**TECHNICAL BULLETIN**

TB: 20080805

**TO: Owners of SCOTT® SCBA Equipped with Heads-Up Display**  
**FROM: Rick Hofmeister**  
**SUBJECT: Addition of Anti-Rotation Clamp**  
**DATE: May 8, 2008**

**FIGURE 1 – Single Outlet Pressure Reducer**

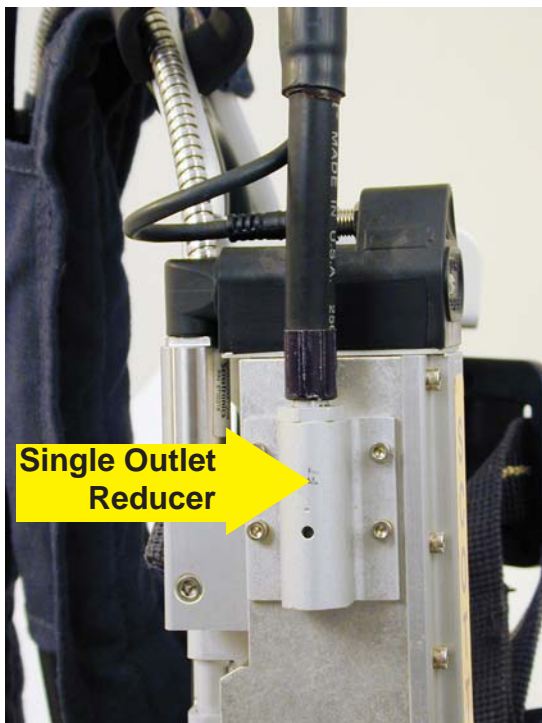
SCOTT is advising all owners of Air-Pak® SCBA equipped with Heads-Up Display of the availability of a user installable Anti-Rotation Clamp. The Anti-Rotation Clamp is available in two configurations dependent on the type of reducer outlet to low pressure hose connection found on the SCOTT Air-Pak® SCBA. The figures below show the two styles of outlets found on SCOTT SCBA and are labeled Single Outlet Reducer and Dual Outlet Reducer.

**FIGURE 3 – Single Outlet Reducer Hose Clamp, SCOTT P/N 200718-01**

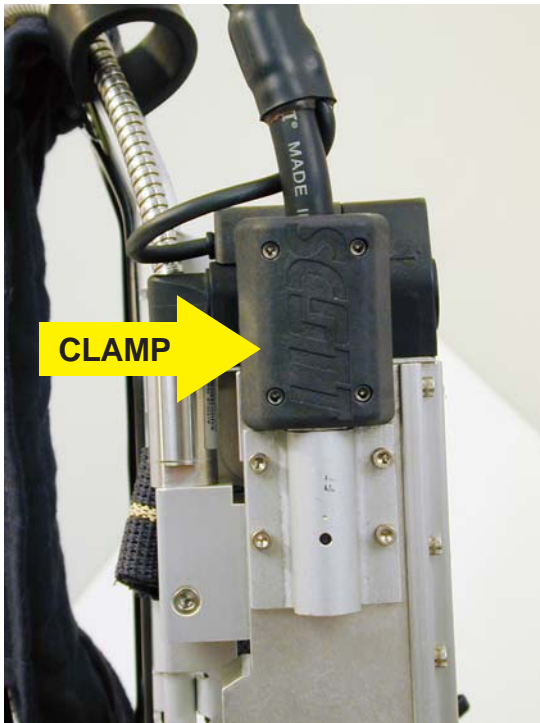
Once the Anti-Rotation Clamp is installed, the movement of the low pressure hose at the electrical connection is limited eliminating stress from repeated twisting on this connection. Units that are equipped with the Anti-Rotation Clamp will appear as shown below:
